PLAN COMMISSION

DATE: MONDAY, OCTOBER 12, 2026

To: Village of Cambridge Planning Commission
From: MSA Planning Staff
Subject: 600 Kenseth Way Zoning Text and Map Amendments
Date: October 6th, 2026

To: Village of Cambridge Planning Commission
From: MSA Planning Staff
Subject: 225 Jefferson Street – Vehicle Repair Use Interpretation
Date: October 6th, 2026

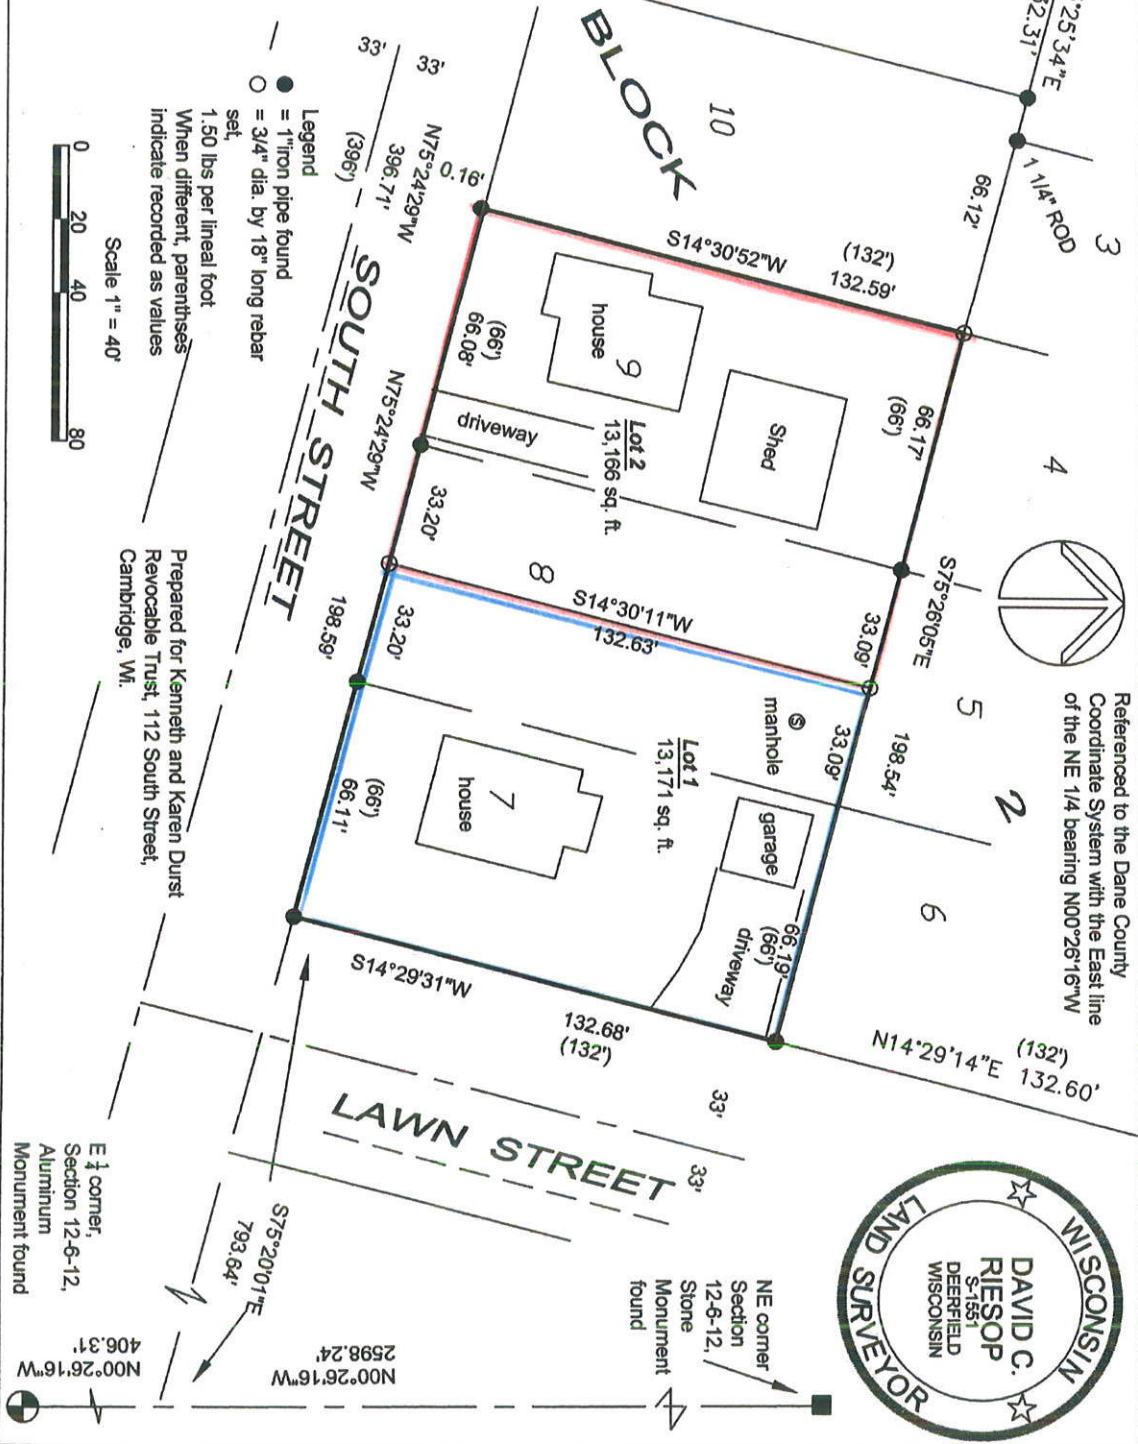
Proposed Lot 1 will be the Rahn parcel and outlined in Blue.

Proposed Lot 2 will be the Durst parcel and outlined in Red.

Blue: sidewalk required by the condition of approval
(ROW has already been dedicated)

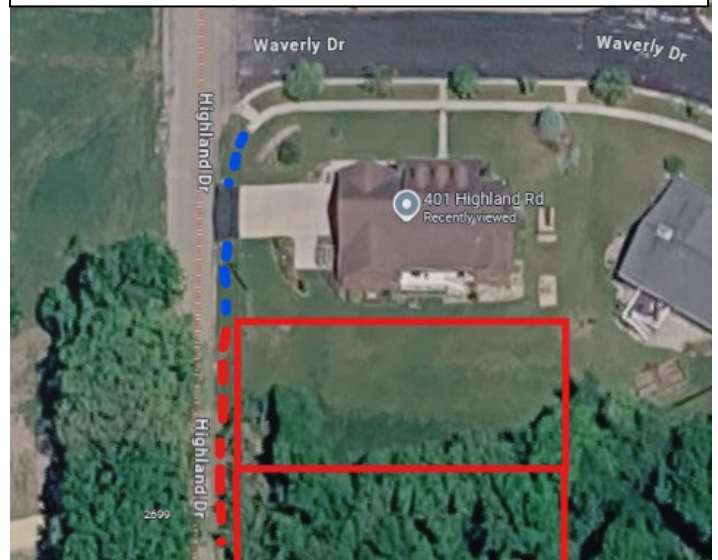
There was some discussion at the Village Board meeting regarding Condition 9, which requires extension of sidewalk along the east side of Highland Drive from Waverly Drive to the southern boundary of Lot 44. The condition also requires the developer to construct and pay for the missing sidewalk segment through the existing right-of-way fronting 401 Highland Road. The existing right-of-way in front of the First Addition Lot at the corner meets the 40-feet from centerline, and the proposed plat will also dedicate to allow a 40-foot right-of-way from the centerline. This provides the necessary area to provide a sidewalk in the right-of-way along Highland Drive. T

8. **[remove?] The area currently occupied by Lots 25-43 shall meet the dimensional standards of the R-L Low Density Residential District.**
9. Sidewalk shall be constructed along the east side of Highland Drive from Waverly Drive to the southern boundary of Lot 44. The Development Agreement shall require the developer to bear the cost of and construct the sidewalk, including the portion of public right-of-way fronting 401 Highland Drive (Lot 34 from Summer Prairie First Addition).

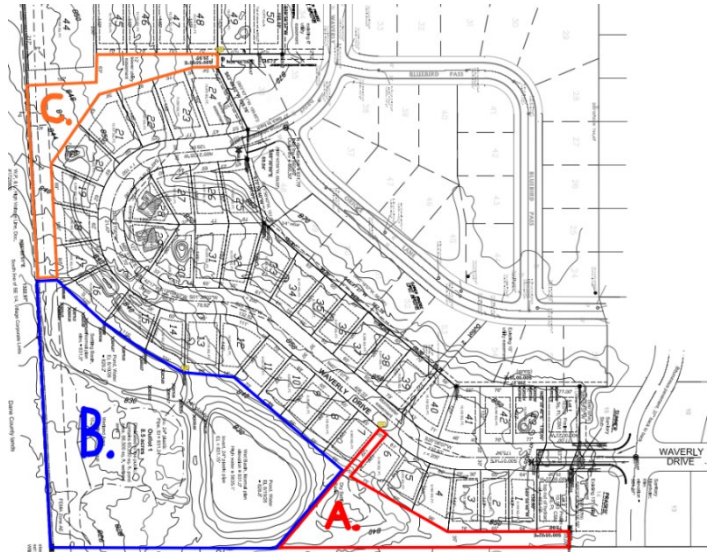
At the Village Board meeting, the developer mentioned that portions of Outlot 1 should be credited toward the Village's parkland dedication requirement, thereby reducing the required fee-in-lieu-of- payment. The Board discussed the possibility of accepting some qualifying land for parkland dedication credit.

- A pedestrian/bicycle **trail only counts if it is within a greenway at least 50 feet wide**, is attached to a neighborhood or mini-park, and does not replace the required active recreational area.
- Wetlands, floodplains, stormwater management areas, drainageways, street right-of-way, **trail-only land**, and “left over,” unwanted, or development-restricted land do not count.
- Conservancy or other open-space land may be accepted by the Village as a donation **but does not satisfy the parkland dedication requirement**.

The approximately 8.4 acres of undeveloped/outlot land can generally be separated into three areas for purposes of this discussion:

Section A is slightly more than one acre, connects directly to Waverly Drive, and has an area that could accommodate a trail, playground, and/or usable recreational area. Of the three areas, this is the portion that could most reasonably be considered for parkland dedication credit. **Acceptance would remain subject to the Village Board determining that the land satisfies the ordinance.**

Partial dedication is addressed through 25%, 50%, and 75% dedication tiers, with the corresponding fee-in-lieu reduced to 75%, 50%, or 25%, respectively. **The separate park impact fee remains applicable. The exact parkland credit does not need to be resolved in order to determine whether the general Preliminary Plat layout is acceptable. However, the Plan Commission may provide a recommendation for the Village Board's consideration.**

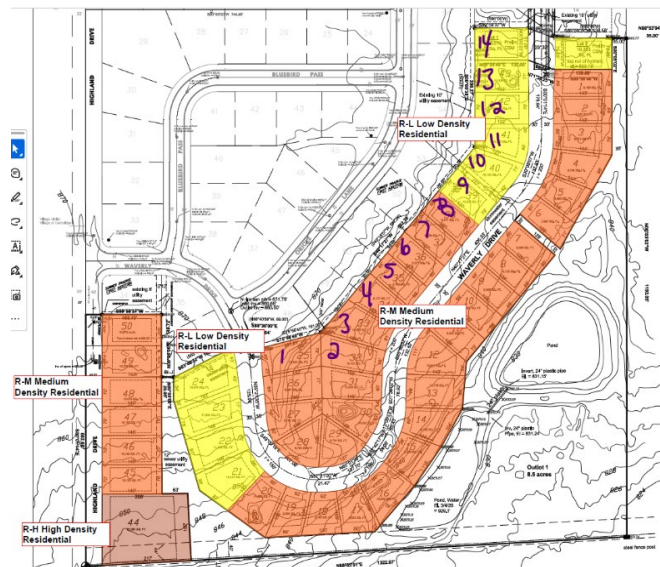
Condition 8 was the primary issue discussed by the Village Board and is the principal item being returned to the Plan Commission. As you recommended, the condition stated Lots 25-43 shall be dimensioned to meet the R-L zoning district to be closer to the size of the existing R-L zoned neighborhood lots. The developer has objected to this condition on the grounds that R-L dimensions would result in the loss of approximately two lots and negatively affect the financial feasibility of the project.

The lot sizes for the section abutting the existing neighborhood includes seven lots per the current plat, as illustrated on the next page (i.e., purple numbers 1,3-8). The average lot size of the existing homes with backyards abutting the plat lots in question averages around 11,500 square feet in size and 90-foot in width. The amended R-L zoning requires minimum lot standards of 10,000 square feet and 75 feet width, while R-M zoning requires minimum lot standards of 8,000 square feet and 60 feet width. The variability in lot size between existing abutting

lots and the zoning minimums are as follows: reduction of 13% and 17% to the minimum of R-L requirements, or a reduction of 30% and 33% with R-M zoning minimum standards. As visible in the plat exhibit (shown below) it presents a roughly 1.25-1.5 lots in the plat as compared to existing lots abutting the proposed plat.

The developer stated that the homes proposed on the R-M lots would not necessarily be smaller than those he would build under R-L simply because the lots are smaller. MSA notes the existing homes are between 60-70 feet wide, and the proposed R-M lots would provide a narrower buildable envelope, generally around 50 feet after side-yard setbacks.

The Board did not provide direction to either retain or remove Condition 8. Removing Condition 8 would allow the Preliminary Plat layout to proceed without prejudging a later zoning decision. The approval of a future final plat would need to be revised if future rezone is not approved and adopted by ordinance. If you want to soften the language of Condition 5, it may read as follows:
